REGIONAL REVIEW FINDING

ARC REVIEW CODE: R1911082

TO: Mayor Rochelle Robinson, City of Douglasville
ATTN TO: Patrice Williams, Community Development Director
FROM: Douglas R. Hooker, Executive Director, ARC
RE: Development of Regional Impact (DRI) Review

Name of Proposal: Rock Quarry -- 2019 (DRI #2983)

AMENDED CONCEPTUAL PLAN
PSLUP 19-0005

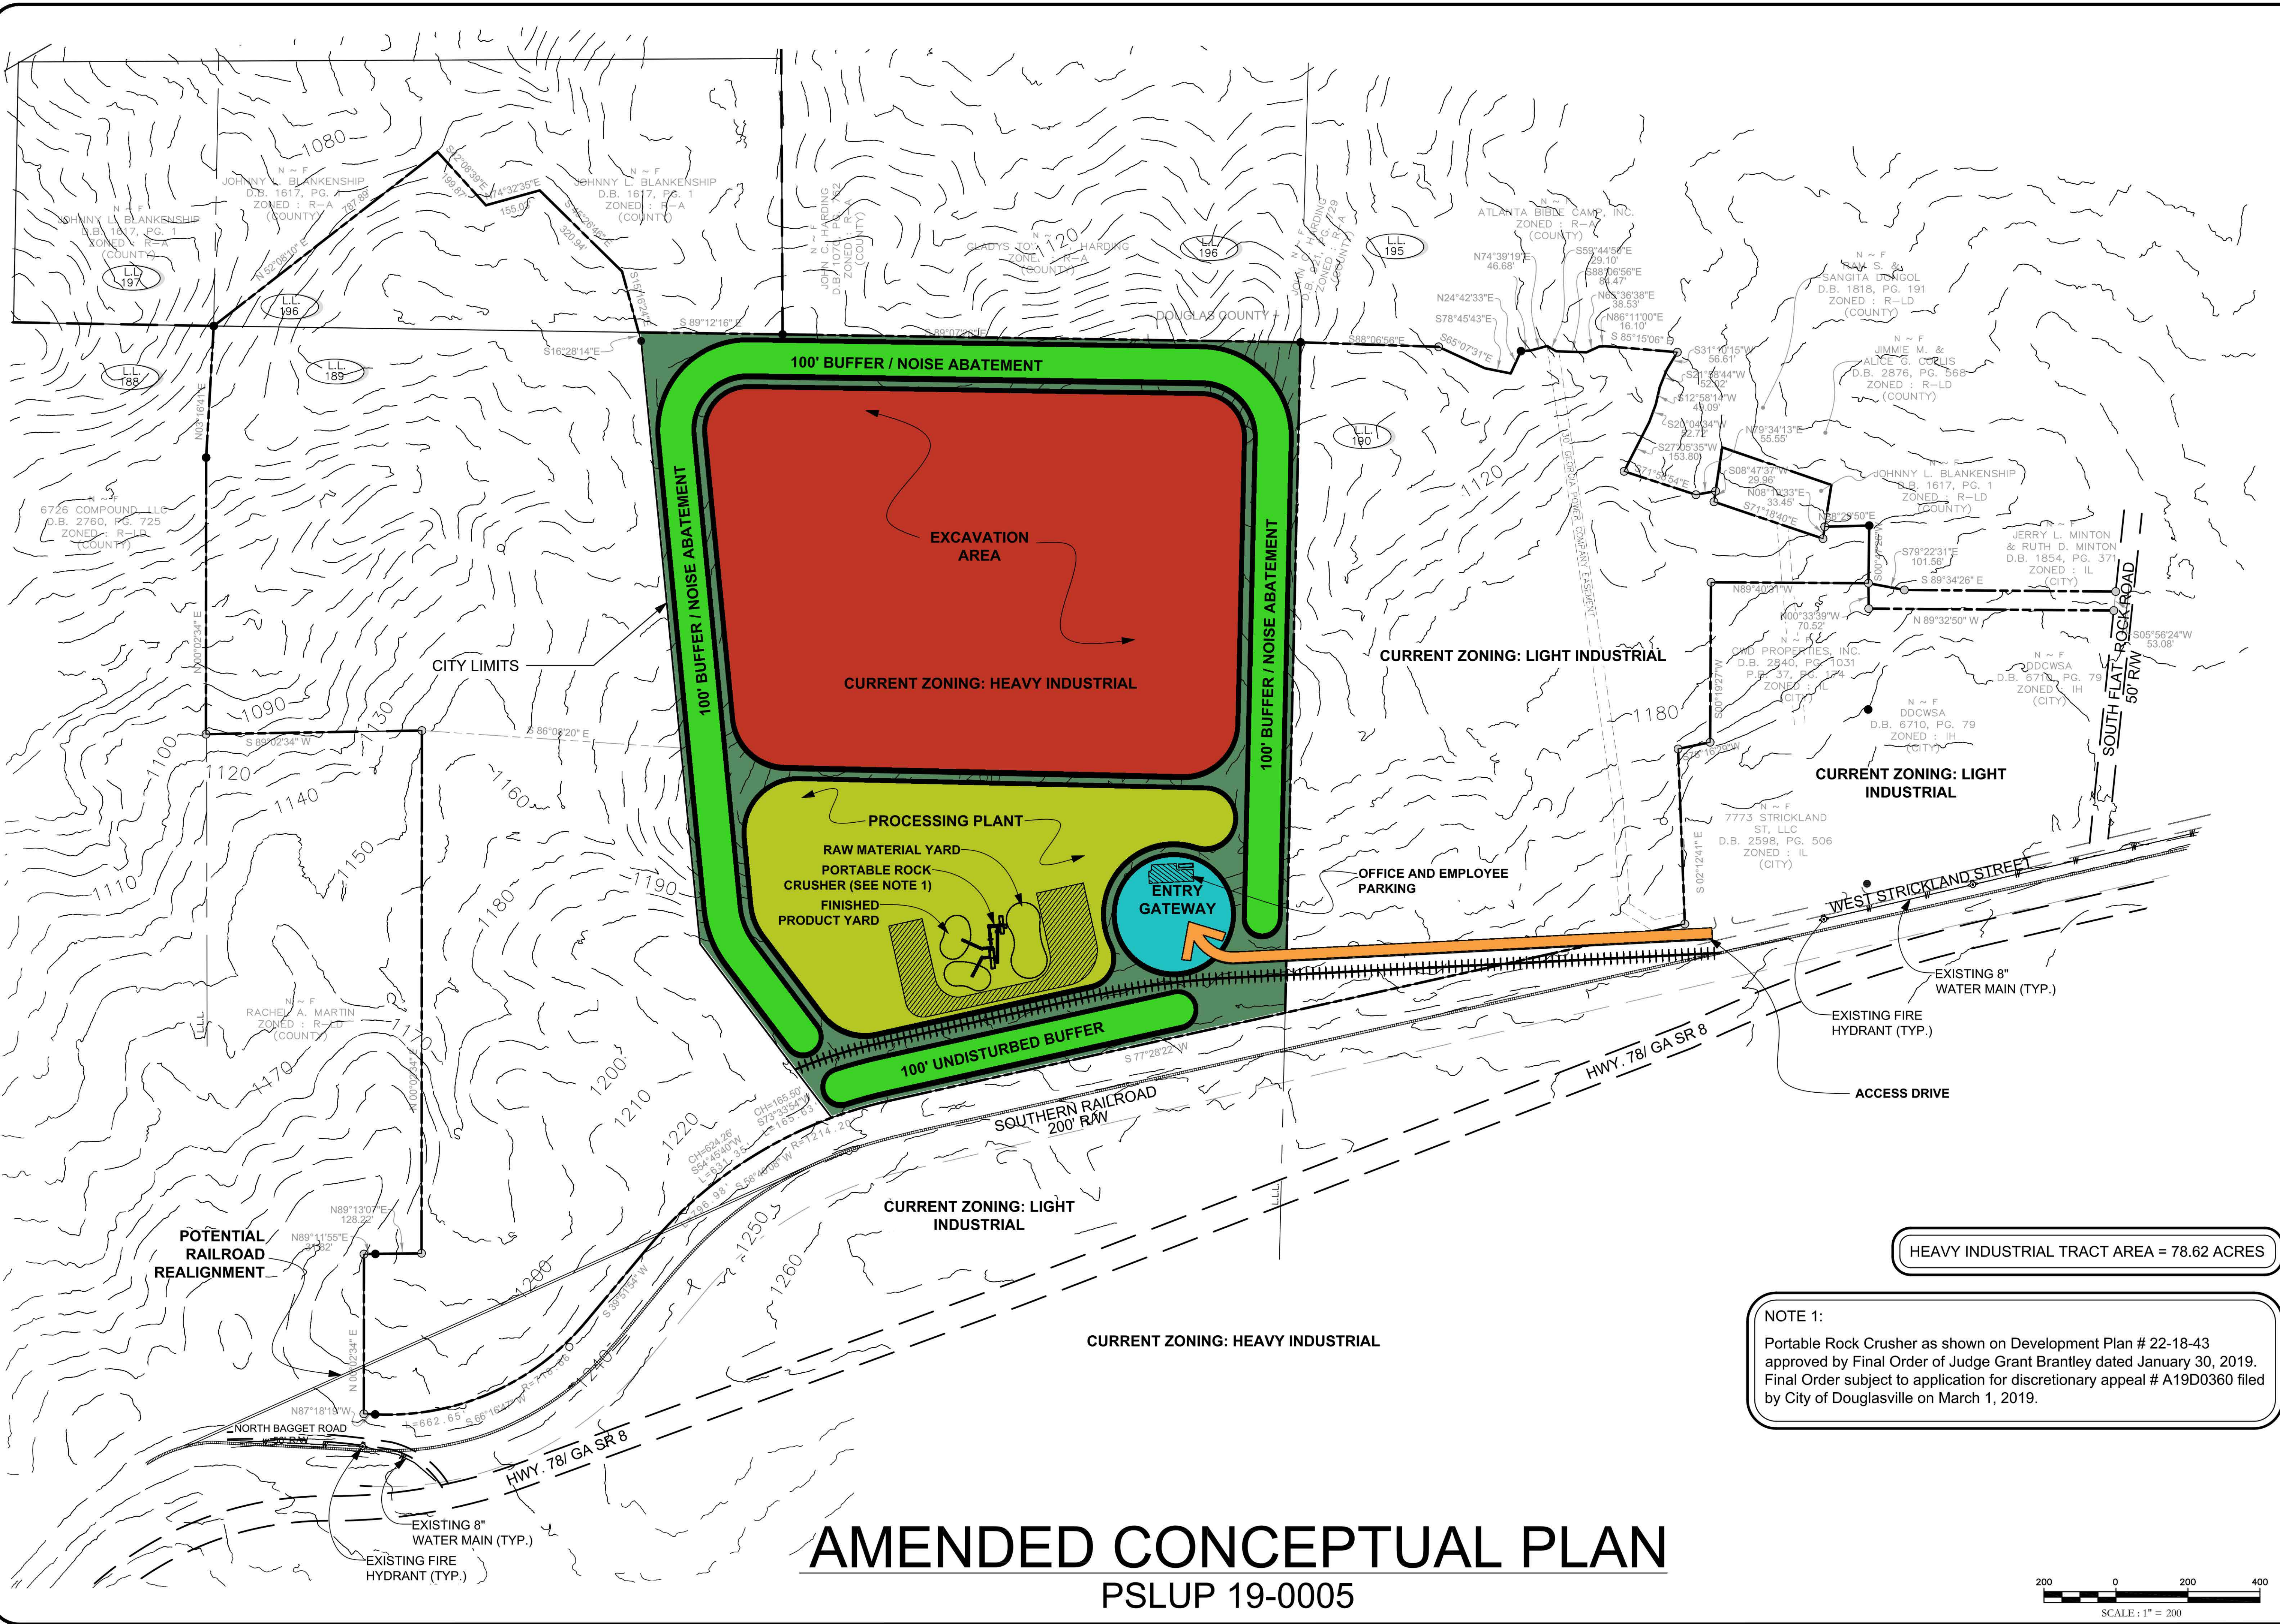
Attached is the concept site plan on the 78.62 acre tract in the city of Douglasville. Note that the subject property does not have direct access to a street. The only access is from West Strickland Street through an adjoining tract of land. That access is through a tract zoned light industrial which does not permit a quarry under the zoning ordinance. This is, after all, a rock quarry which should demand that direct access is critical to the safe and efficient operation of a quarry. We contend that the Douglasville ordinances do not allow access to a heavy industrial zone in which a quarry is allowed through a light industrial zone in which a rock quarry is not allowed.

Traffic impact is critical to an evaluation of the DRI. As shown on the attached concept plan, access to the quarry site is only from West Strickland Street which intersects South Flat Rock Road. Traffic to and from the quarry will have to traverse this intersection which is approximately 600-700 feet from the access road to the quarry. It can be expected that the heightened truck traffic will result in a serious back up and congestion at this intersection, especially in the mornings and afternoons during peak traffic times.
